ARCHITECTURAL REVIEW BOARD STAFF REPORT

Project #/Name	ARB-2023-26: Regents School of Charlottesville
Review Type	Site Plan Amendment
Parcel Identification	07600-00-00-01700, 07500-00-00-06600 (See Figure 1.)
Location	2010 Coram Deo Drive
Zoned	Residential (R1) / Entrance Corridor (EC)
Owner/Applicant	Regents School of Charlottesville Inc. / Shimp Engineering (Rachel Moon)
Magisterial District	Samuel Miller
Proposal	To amend the approved site plan (SDP-2020-52) to add 6 upper school buildings, increase the size of the athletic field, add a practice field, shift the lower school building 30' to the north, establish a new central water supply for the school and expand the central sewerage system, and to approve the color and material of all the school buildings.
Context	The property has been cleared and graded; construction is under way. Foxhaven Farm is across Reservoir Road to the north. Low density residential uses are nearby. Trinity Presbyterian Church is to the east. The I-64/Rt. 29 Bypass interchange is adjacent to the south.

Figure 3: Classroom buildings as illustrated in 2020 EC submittals.

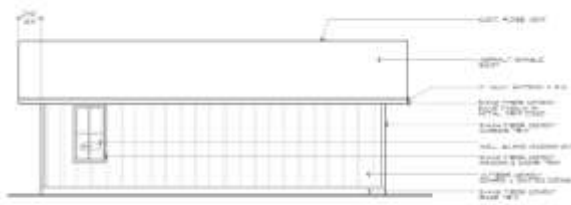
tones. (See Figure 3.) Site sections suggested that the school buildings wouldn't be visible from the EC. The application was approved by staff in July 2020 as a final site plan based on the expected low level of visibility.
